# Improved Technical Specifications

## LaSalle County Station

Volume 5:  
Sections 3.4 and 3.5

Figure 3.4.6.1-1

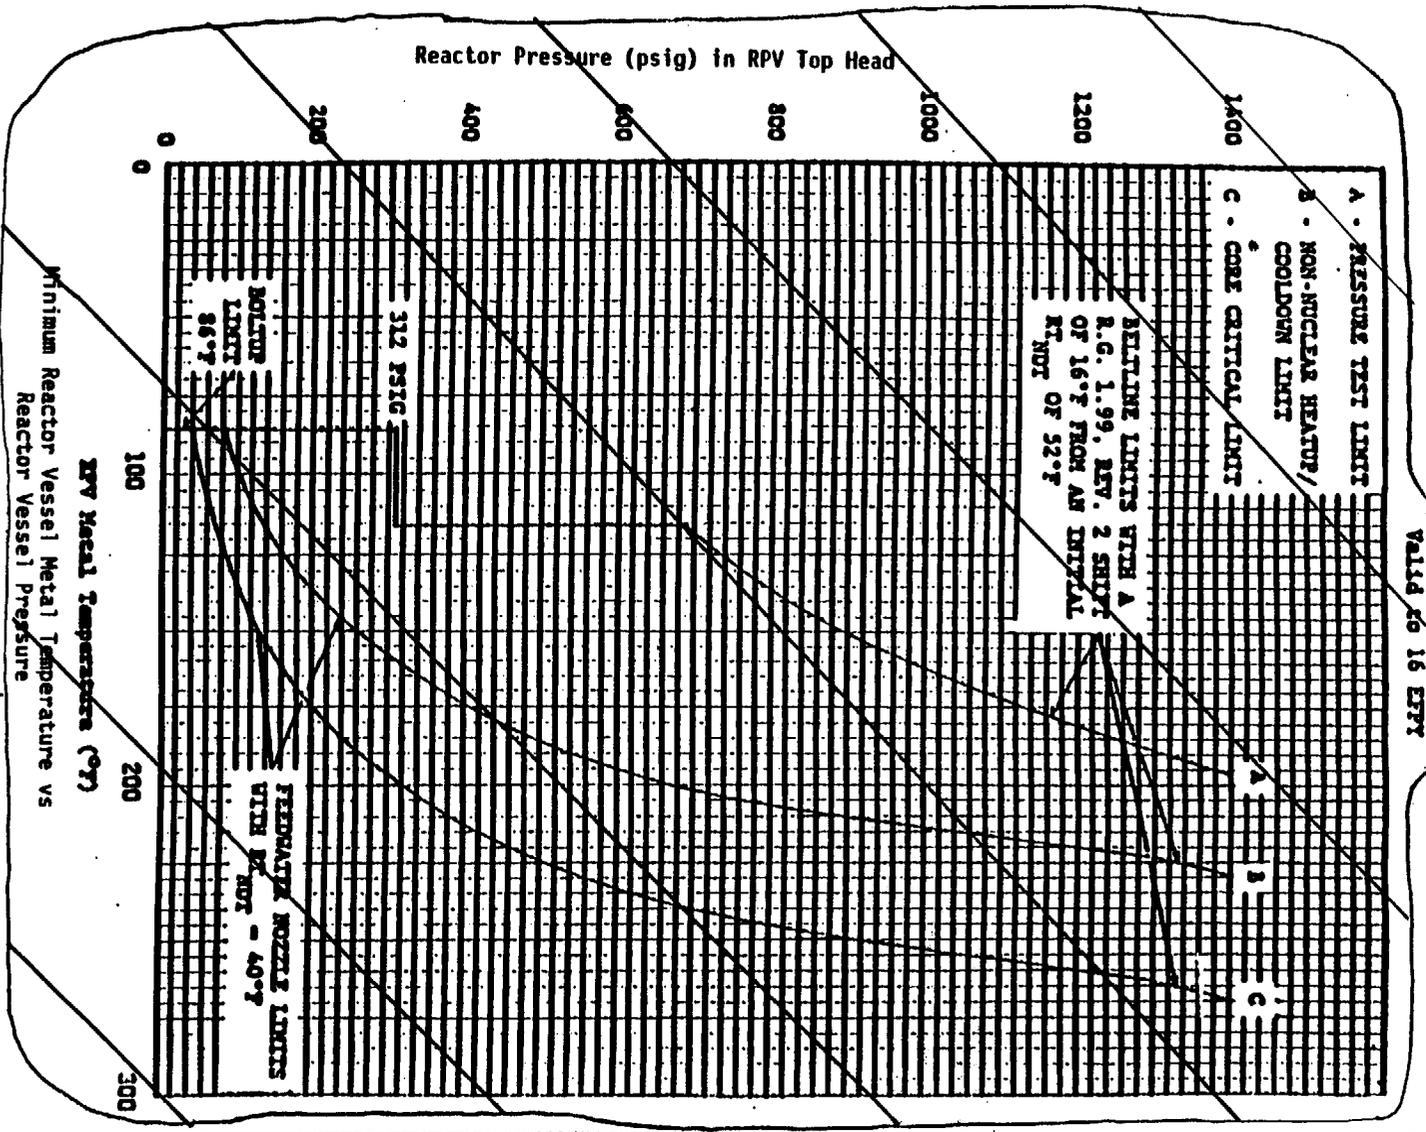
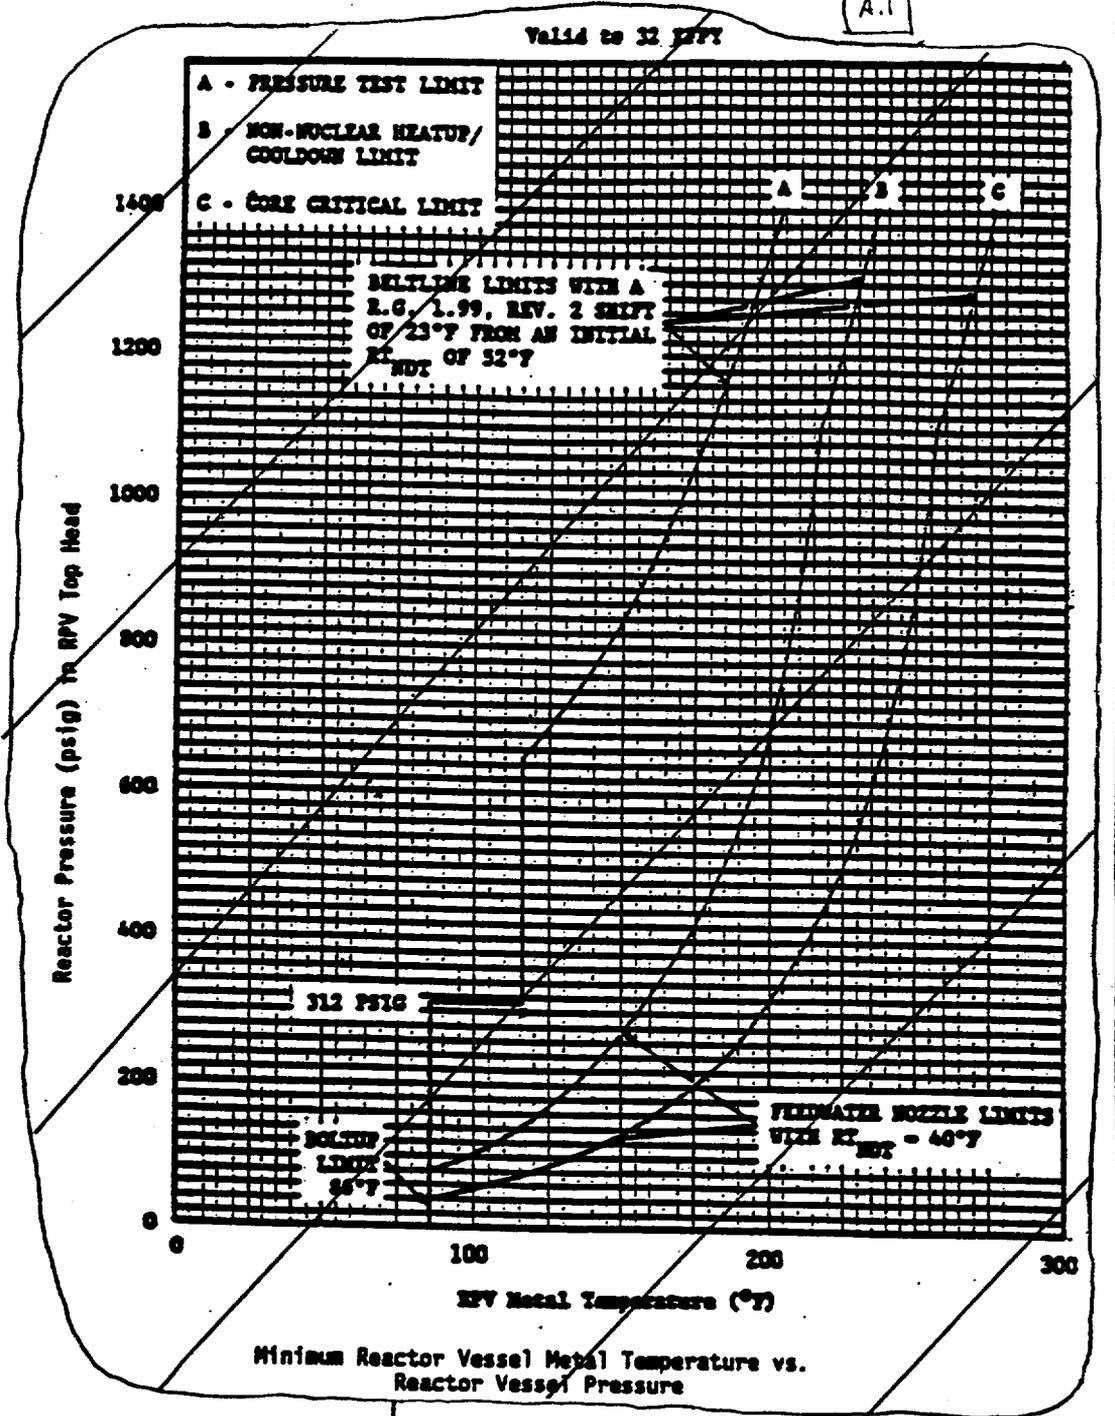
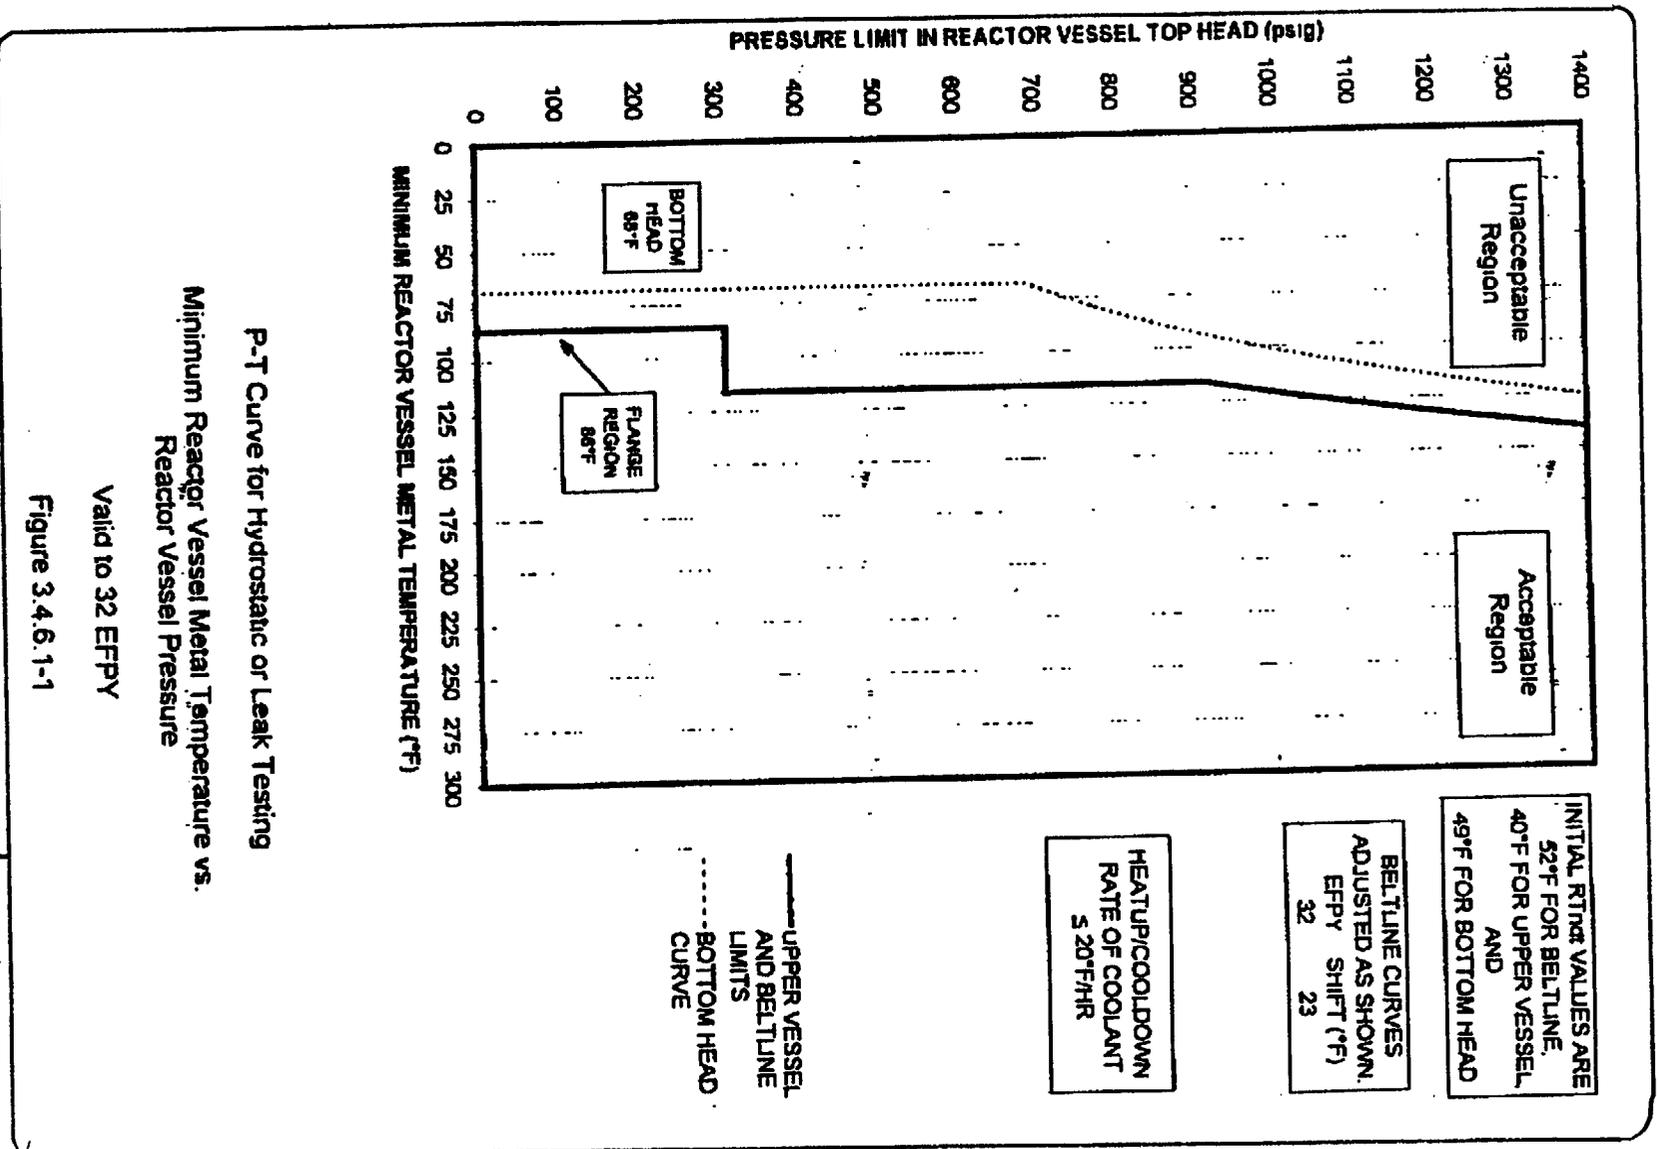
Replace with Figures 3.4.6.1-4, 3.4.6.1-5 and 3.4.6.1-6  
3/4 4-19a

- LA.1      The specific requirements in CTS 4.4.6.1.1 and CTS 4.4.6.1.2 that operation be to the right of the limits lines of Figures 3.4.6.1-1 and 3.4.6.1-1a are proposed to be relocated to the Bases. These details are not necessary to ensure the P/T limits are met. The requirements to maintain the P/T limits in accordance with the Figures are still maintained in ITS 3.4.11, SR 3.4.11.1, and SR 3.4.11.2. Therefore, the relocated requirements are not required to be in the ITS to provide adequate protection of the public health and safety. Changes to the Bases will be controlled by the provisions of the proposed Bases Control Program described in Chapter 5 of the ITS.

Figure 3.4.1-1 (Page 1 of 1)  
Power versus Flow

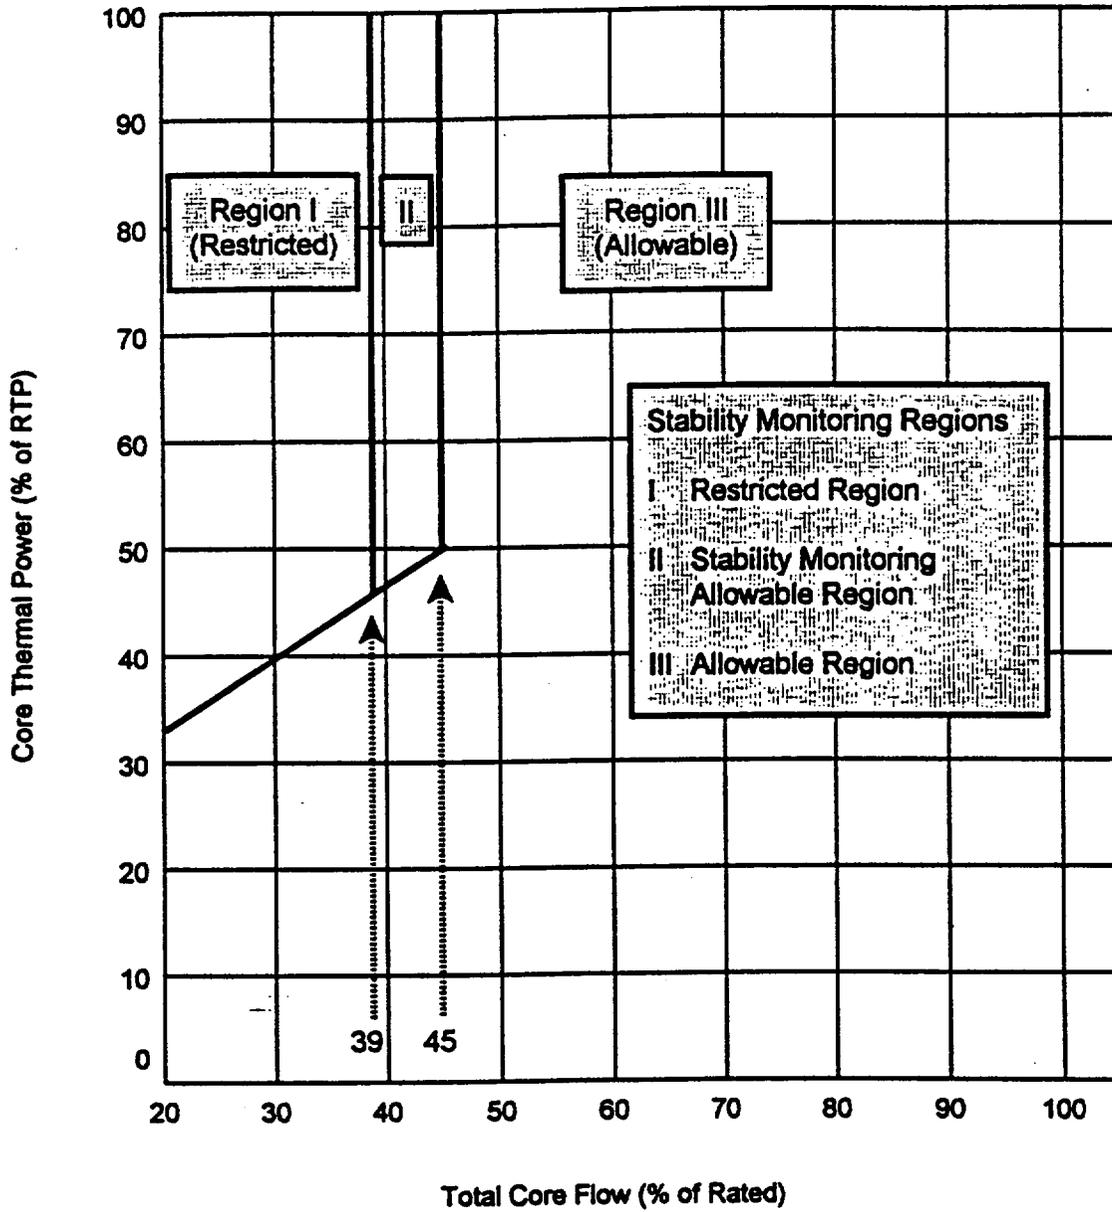
<Figure 3.4.1.5-1>

SR 3.4.1.2 Verify operation is in Region III of Figure 3.4.1-1. 24 hours
